CALL NO. 102
CONTRACT ID NO. 121001
ADDENDUM # 2

Subject: Pike County, APD 0806 (040)
Letting January 27, 2012

- (1) Revised - Plan Sheets - T1, T56, T57, & T58
- (2) Revised - Bid Items - Pages 84-88 of 88

BILL OF REINFORCEMENT FOR FOOTING

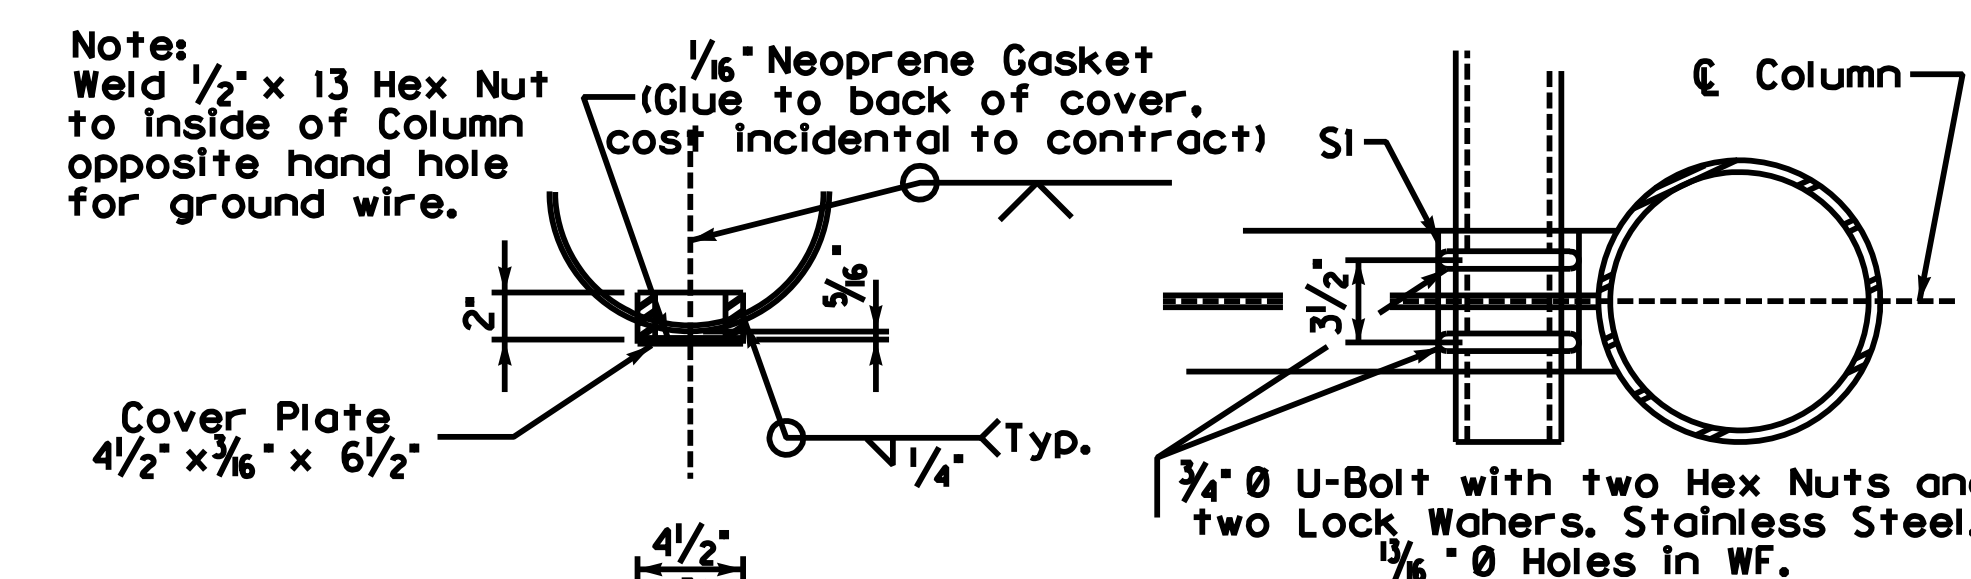
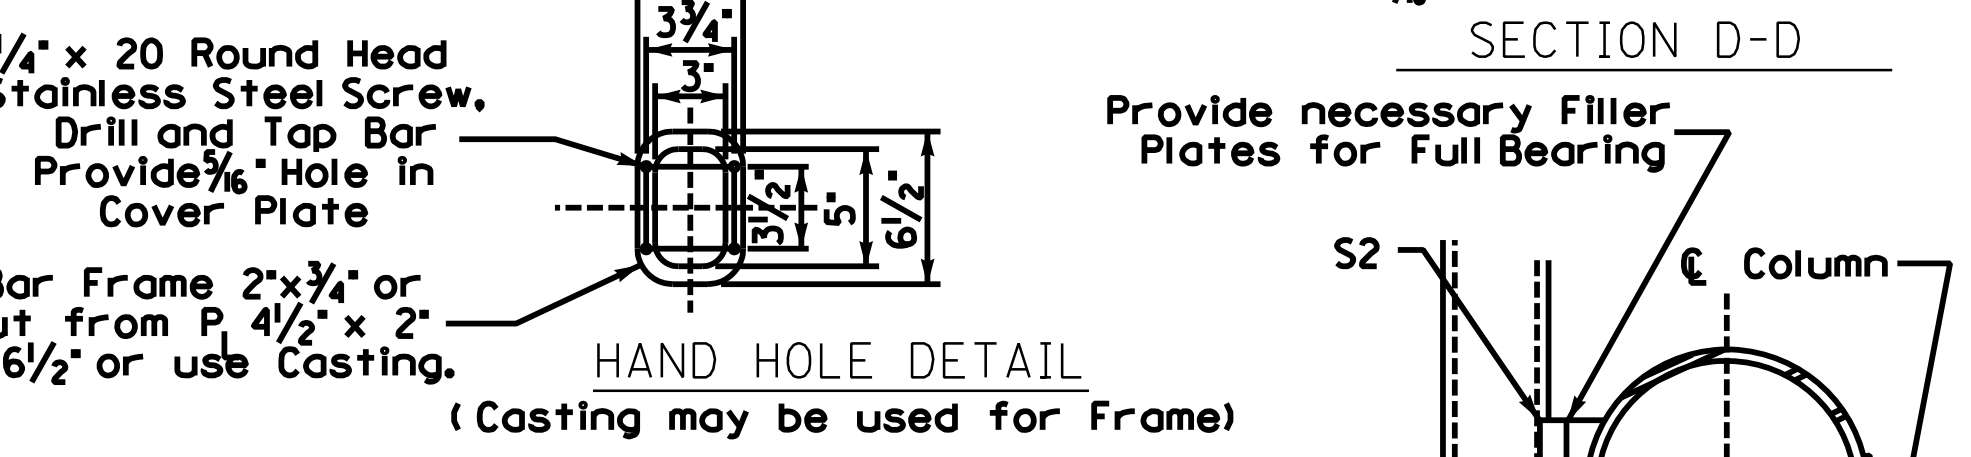
1 MODIFIED NOTE

NOTE: SIGN TRUSS FOUNDATION DATA (UP TO BASE PLATE) FOR INFORMATION ONLY. SUPERSTRUCTURE TO BE CONSTRUCTED UNDER THIS PROJECT.
